# **SERVICE BULLETIN**

<sub>N°</sub> 139-664

**DATE:** October 28, 2021

ATA 25 - D-LOCK HOOK BREEZE HOIST INSTALLATION

Figure 1

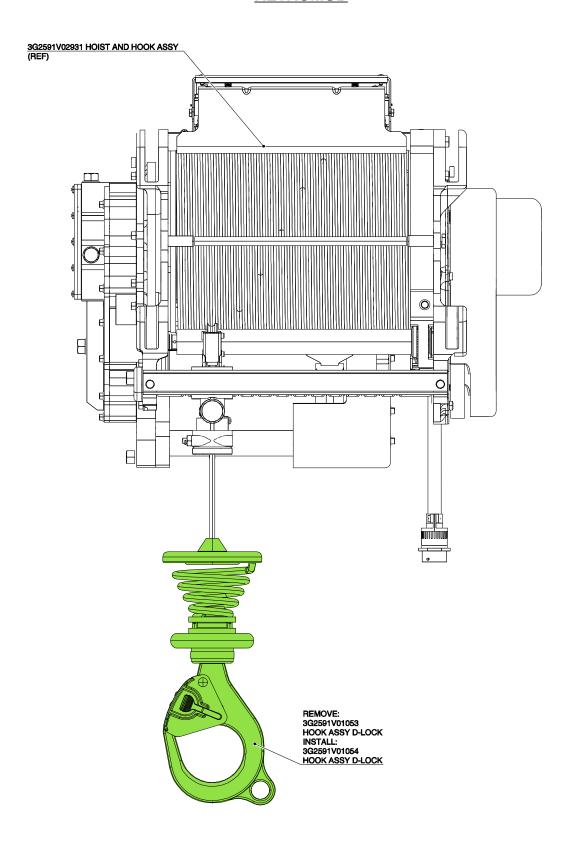
- 2. With reference to Figures 1 and 3, perform the rescue hoist and hook assy retromod P/N 3G2591P02111 as described in the following procedure:
  - 2.1 In accordance with AMP DM 39-A-25-91-01-01B-520A-K and with reference to Figure 1, remove hook assy D-LOCK P/N 3G2591V01053 from the hoist and hook assy P/N 3G2591V02931.
  - 2.2 In accordance with AMP DM 39-A-25-91-01-01B-720A-K and with reference to Figure 1, install hook assy D-LOCK P/N 3G2591V01054 on the hoist and hook assy P/N 3G2591V02931.

Figure 2

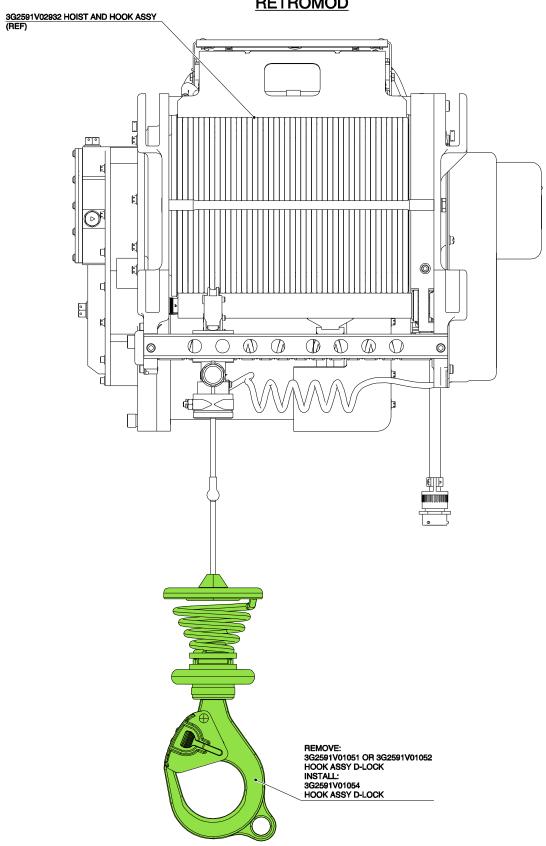
- 3. With reference to Figures 2 and 3, perform the rescue hoist and hook assy retromod P/N 3G2591P02211 as described in the following procedure:
  - 3.1 In accordance with AMP DMs 39-A-25-91-01-01A-520A-K or 39-A-25-91-01-01B-520A-K and with reference to Figure 2, remove hook assy D-LOCK P/N 3G2591V01051 or hook assy D-LOCK P/N 3G2591V01052 from the hoist and hook assy P/N 3G2591V02932.
  - 3.2 In accordance with AMP DM 39-A-25-91-01-01B-720A-K and with reference to Figure 2, install hook assy D-LOCK P/N 3G2591V01054 on the hoist and hook assy P/N 3G2591V02932.

Figure 3

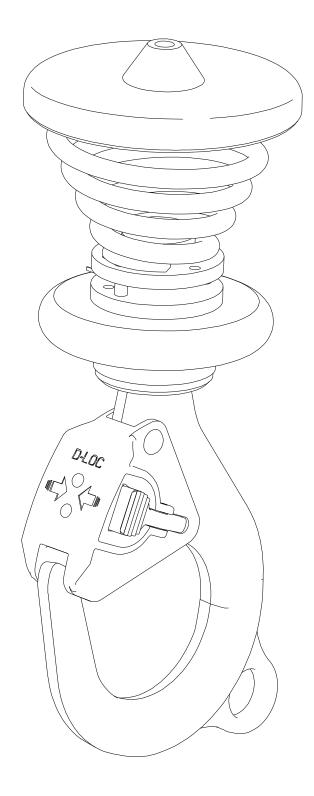
This SB is issued in order to introduce a new rescue hoist hook called D-Lock that allows

swivel and adaptation to the rescue hoist's swaged ball at the end of the wire rope

assembly. Also, the keeper assembly is designed to prevent unintentional opening of

the hook assembly.
